## FIELD OBSERVATION REPORT

*Date:* March 31, 2020 (REV April 10, 2020)      *Project:* Stuberstone Lofts  
Concrete Headers  
*From:* Glen L. Spangler      *Client Project No.:* -  
*To:* Robert Knapp      *DNCE Project No.:* 9819-03  
*Company:* -

Photo No. 11 – Exterior Above Unit 600

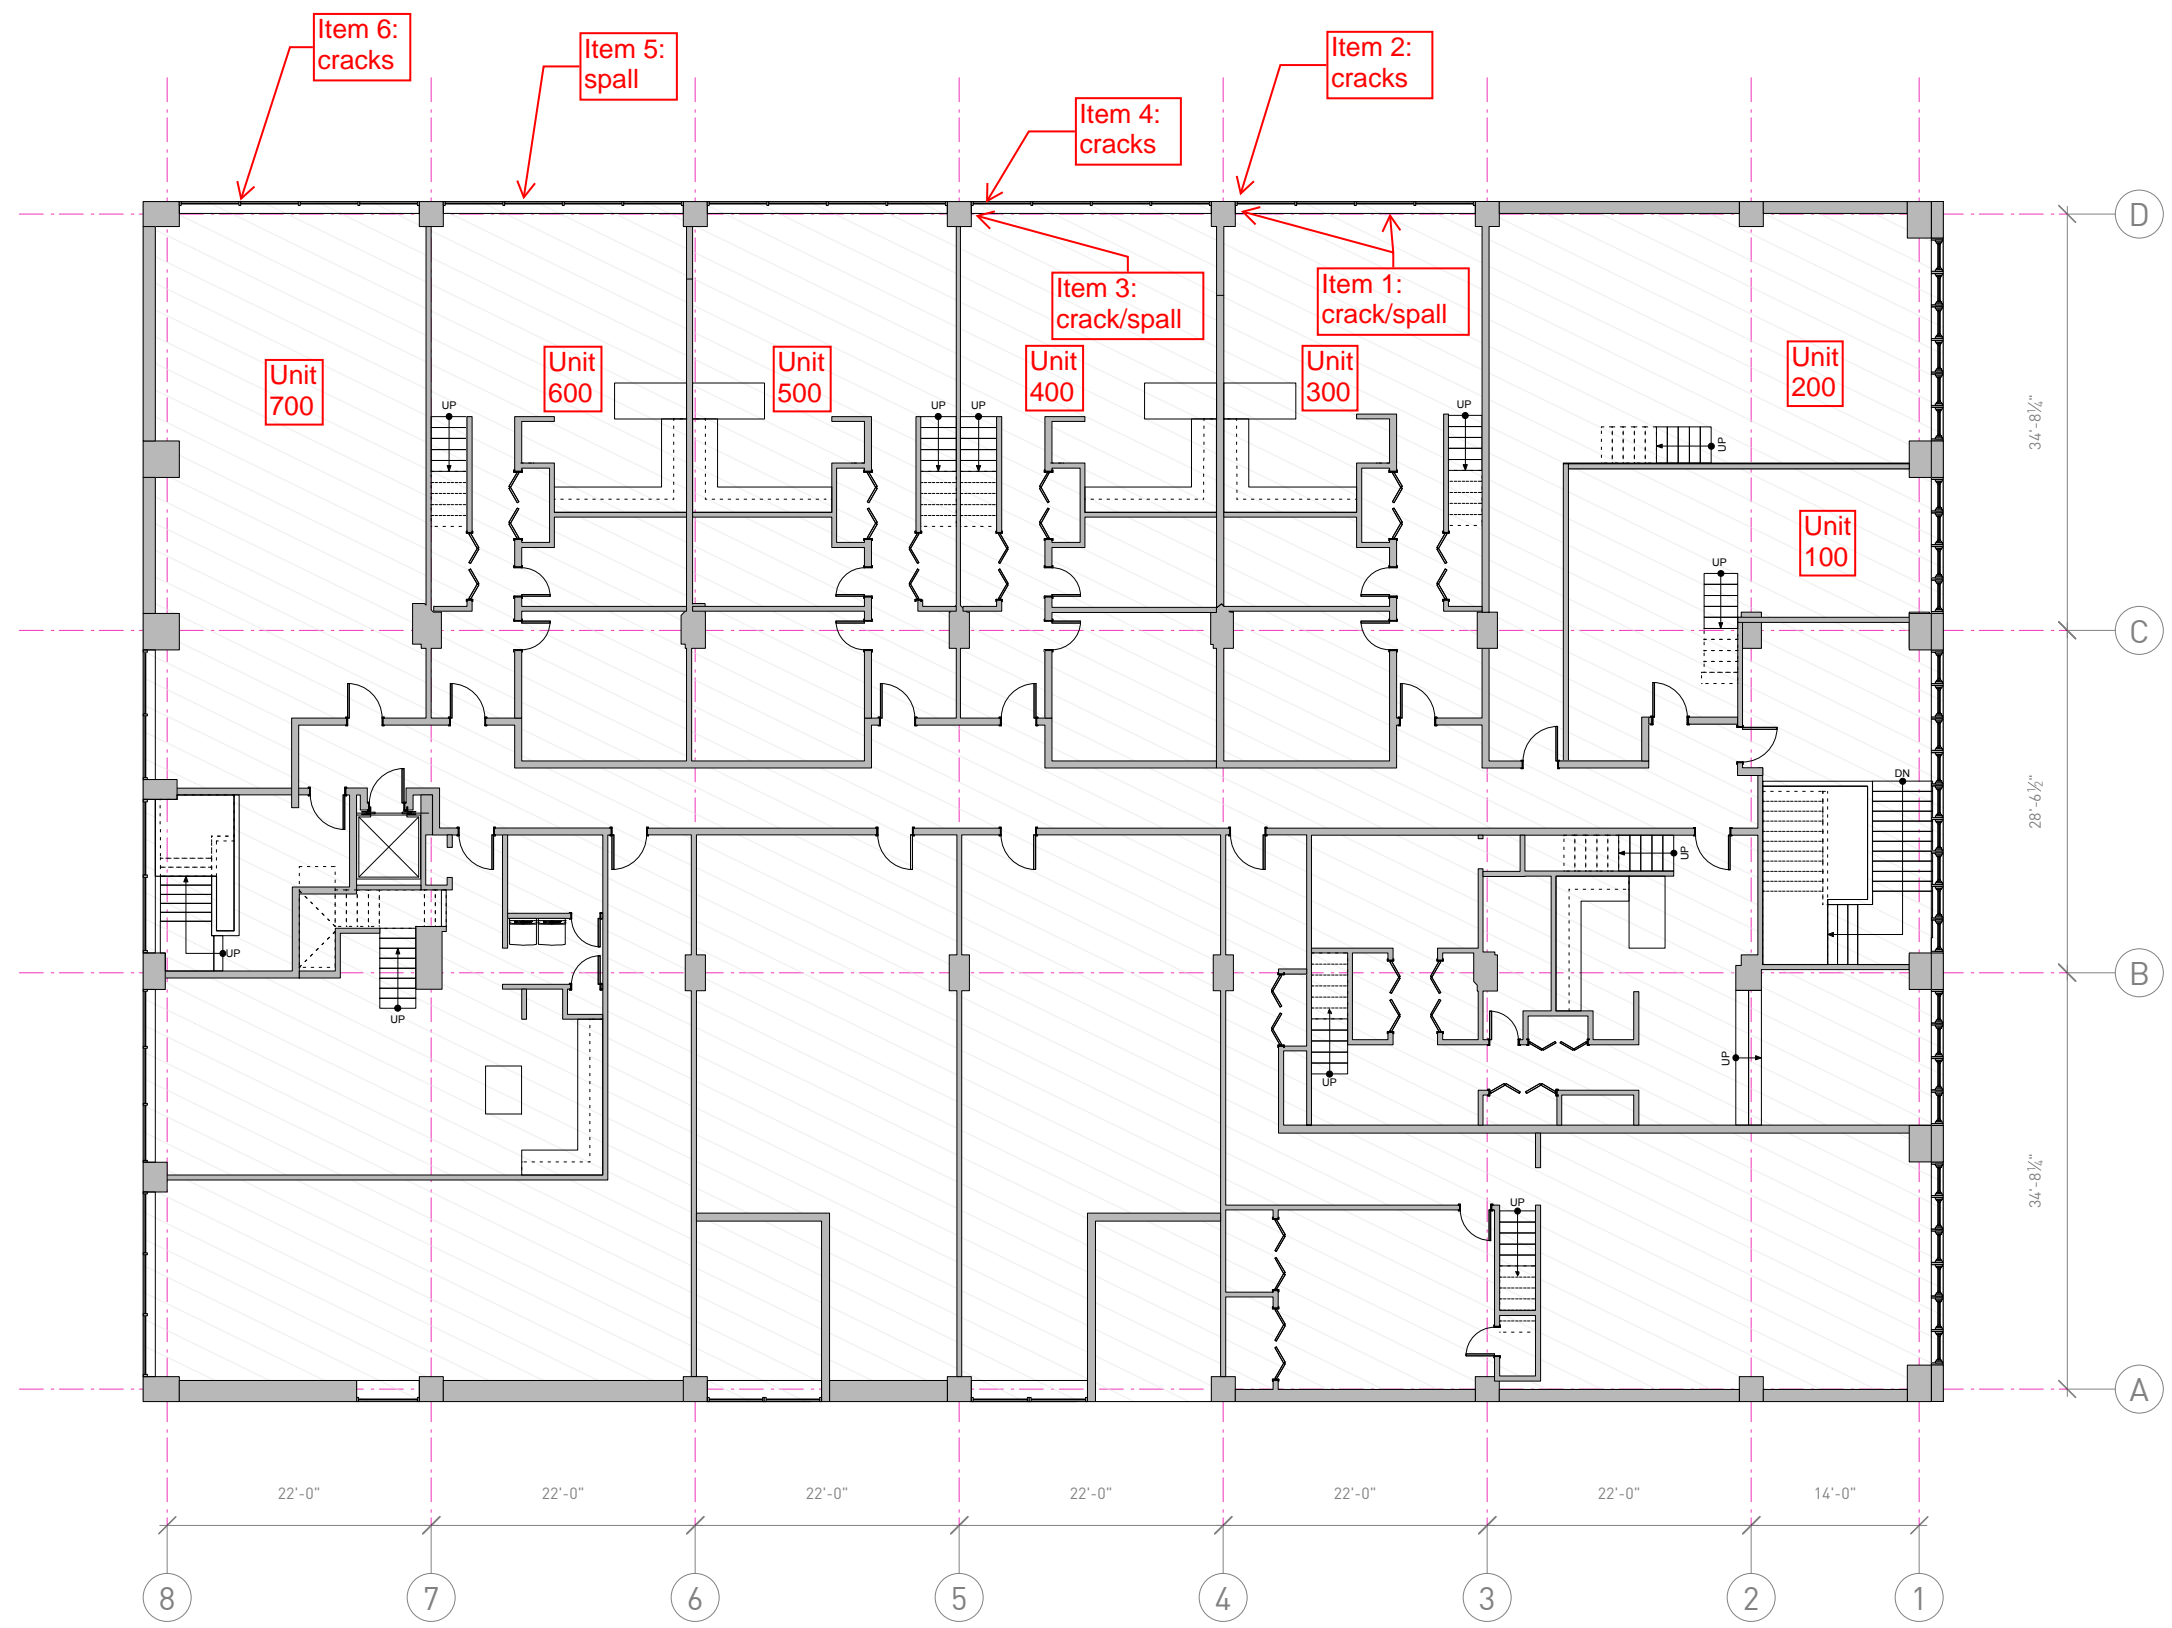
Item No.5: On the exterior of the building, for the beams above the windows, there is some spall  
Refer to Photos 10 & 11.

Suggested repair: Route out cracks. Inject with structural crack repair (SIKADUR 35 HI-MOD LV, Cap seal with SIKADUR HI-MOD GEL). If concrete is delaminated, Remove delaminated concrete, clean corroded reinforcing steel. The reinforcing steel will need to be evaluated for section loss to determine if additional reinforcement is required. Apply SIKA Armatec 110 EpoCem to resteel. Replace removed concrete with repair mortar (Xypex MEGA MIX II, hand applied). Shoring may be required.
